City of San Antonio

Re: **Madison Market**

MDP # 030-07

The City Staff Development Review Committee has reviewed Madison's Market Master Development Plan **M.D.P. # 030-07**. Please find enclosed a signed copy for your files. Your plan was accepted however, please note the following conditions:

MASTER DEVELOPMENT PLAN
 No. 030-07

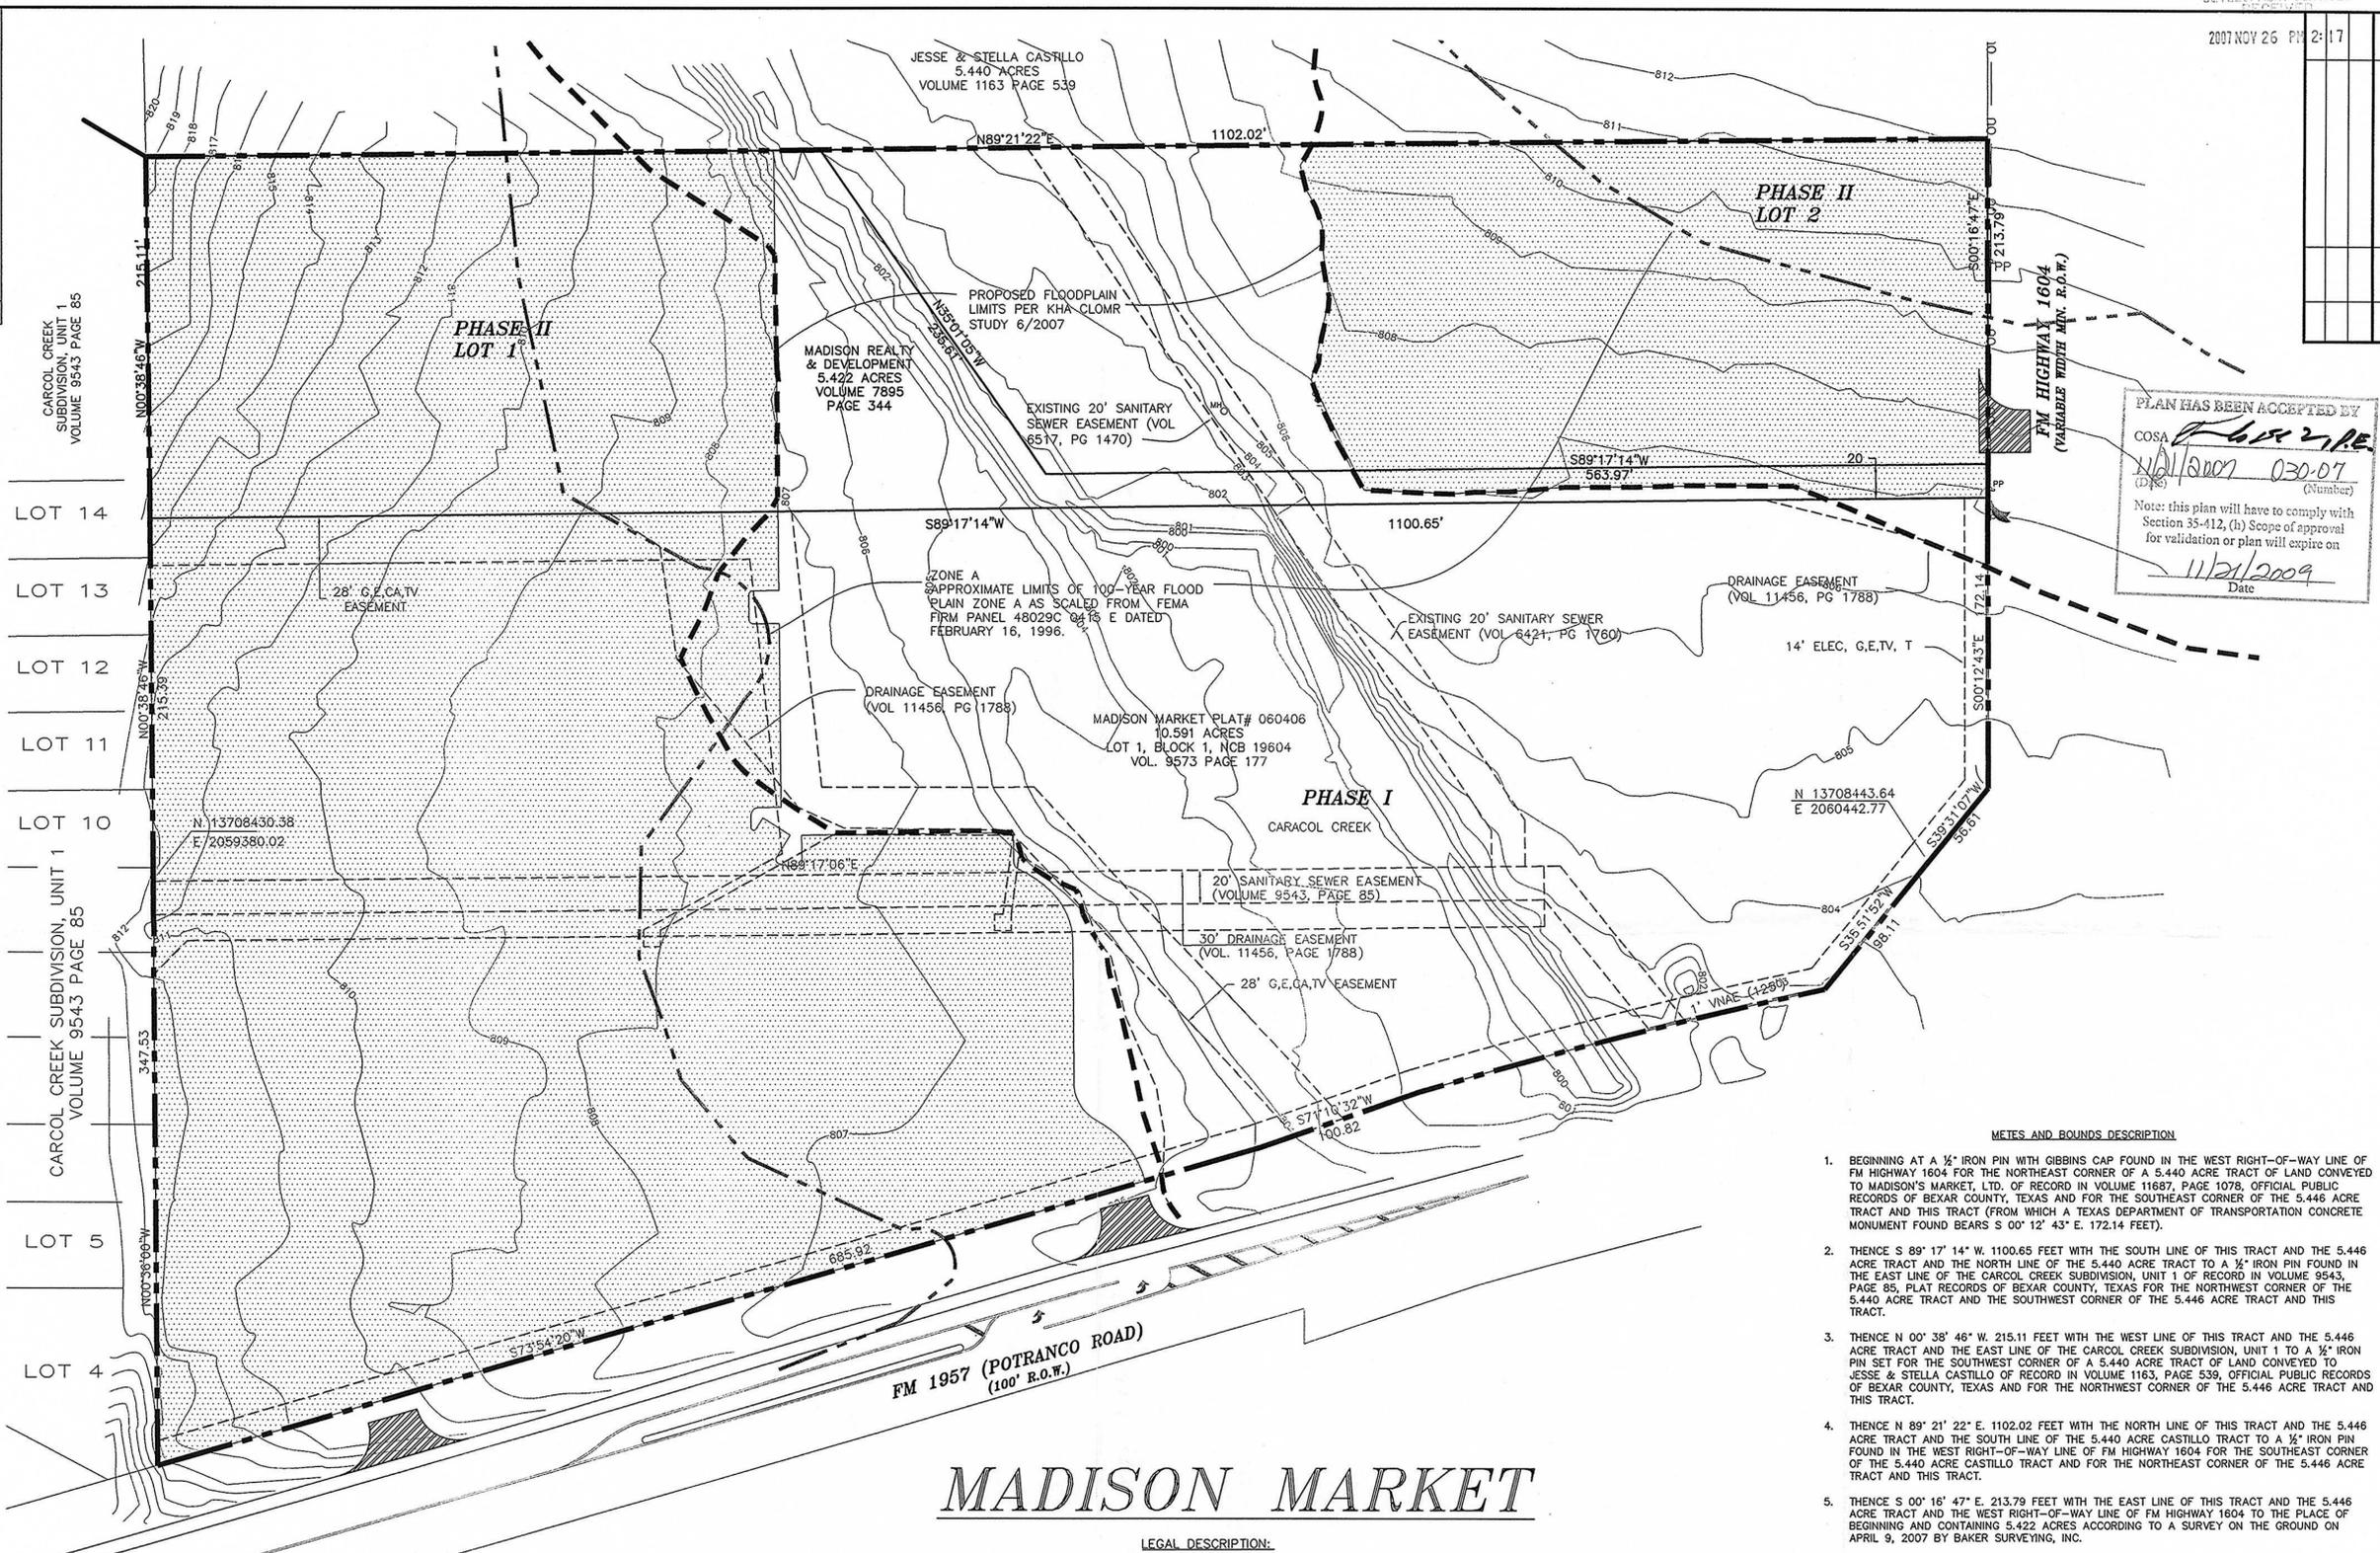
In consideration of public safety and convenience, excessive grades by reason of topography should be avoided in street layouts and arrangements. Any access and R.O.W. issues along state facilities will need to be resolved with the **Texas Department of Transportation (TXDOT)**. For information about these requirements you can contact TXDOT at 615-5814.

- All access roadways shall provide clear sight distance on all existing and proposed roadways in order to provide adequate obstruction free viewing distances for approaching traffic. All signage, landscaping, and improvements shall be selected and located so as to not block these clear sight distance areas.
- All commercial driveways for this project shall comply with UDC 35-506(r) Access and Driveways.
- All driveway access points along Loop 1604 shall be coordinated through TXDOT.
- Coordinate all proposed modifications to traffic signal timing settings on Potranco Road & Waterstone Place with City of San Antonio Public Works Department.

- Coordinate all proposed modifications to traffic signal timing settings on Potranco & NB & SB Loop 1604 with City of San Antonio Public Works and with TXDOT.

- 2006 Tree Preservation ordinance standards per UDC Section 35-523 – A Tree Preservation Plan with 40% preservation of protected trees and 100% of heritage trees is required prior to any work on site. This can be submitted either as a site work permit, at the platting or building permit stage.
- Landscape ordinance per UDC Section 35-511. It appears some landscape points can be met by preserving existing vegetation as well as meeting any mitigation requirements (either through preservation of smaller material or transplanting). Recommend securing knowledgeable Landscape Architect at planning and design phase to better utilize existing trees and vegetation. Preservation will eliminate the need for irrigation. Staff would be willing to meet with developer at design stage to assist with tree preservation and landscape plan.

All platting shall comply with the Unified Development Code (UDC), Master Plan, and Major Thoroughfare Plan for the City of San Antonio. It will be expected that all of the property depicted in your Master Development Plan to include floodplains, drainage areas, and open space shall be platted. It is suggested to work closely with the school district, so they can plan accordingly.
